DEVELOPMENT APPLICATION ACCESSIBILITY REPORT

Project Name LAHC Blacktown Seniors Living (12 units)

Project Address 52-56 Pank Parade, Blacktown NSW 2148

Reference	10361DA
Date	16/11/2022
Revision	2
Attention	Mode Design

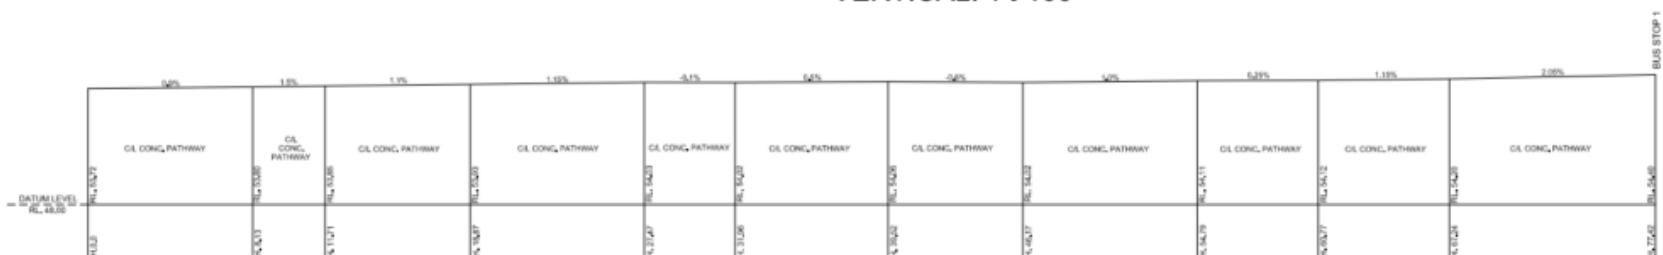
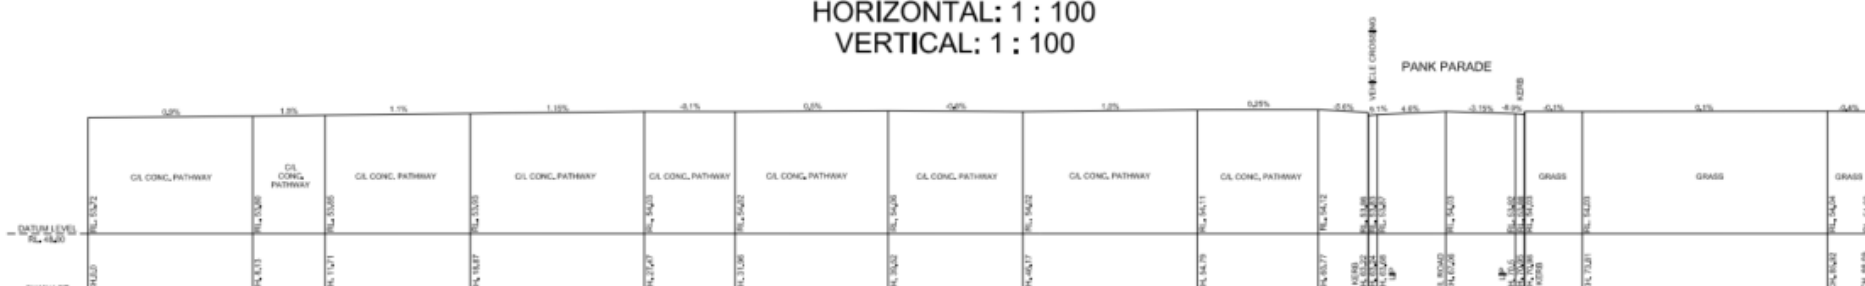
SEPP Requirement	Comments	Status
SEPP Housing Sch 4 Part 1, CI 2		
If the whole of the site has a gradient of less than 1:10, 100% of the dwellings must have wheelchair access by a continuous accessible path of travel in accordance AS 1428.1 to an adjoining public road.	The site has a gradient less than 1:10. Refer snip below that indicates pedestrian gradients are less than 1:10.	Compliance Indicated
<p style="text-align: center;">LONGITUDINAL SECTION 1 HORIZONTAL: 1 : 100 VERTICAL: 1 : 100</p> 		
<p style="text-align: center;">LONGITUDINAL SECTION 2 HORIZONTAL: 1 : 100 VERTICAL: 1 : 100</p>  <p style="text-align: right;">PANK PARADE VEHICLE CROSSING GRASS</p> <p style="text-align: right;">TRANSPORT PROVIDER - SYDNEY BUSES</p>

4.8. Bedroom

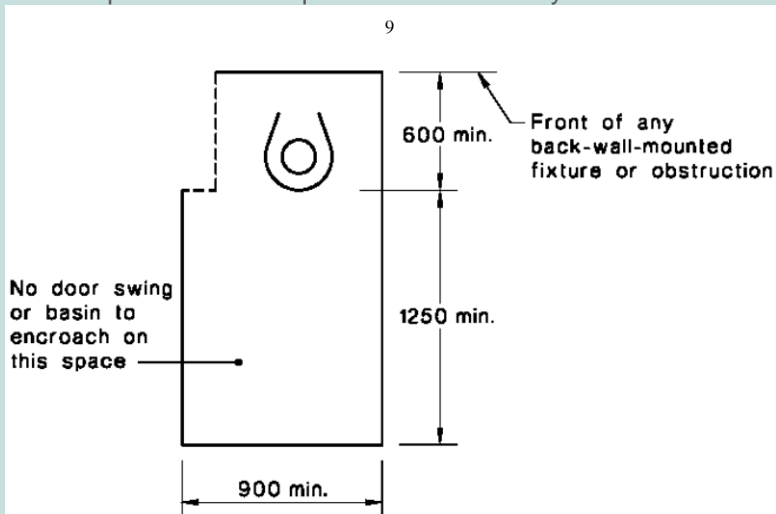
SEPP Requirement	Comments	Status
SEPP Housing Sch 4 Part 1, CI 8		
<p>At least one bedroom within each dwelling must have:</p> <ol style="list-style-type: none"> an area sufficient to accommodate a wardrobe and a bed sized as follows: <ol style="list-style-type: none"> in the case of a dwelling in a hostel—a single-size bed, in the case of a self-contained dwelling—a queen-size bed, and a clear area for the bed of at least: <ol style="list-style-type: none"> 1200mm wide at the foot of the bed, and 	<p>Circulation spaces are indicated to each unit. Further detailed information relating to electrical information will be required to be assessed at Construction Certificate stage.</p>	<p>Compliance Indicated</p>
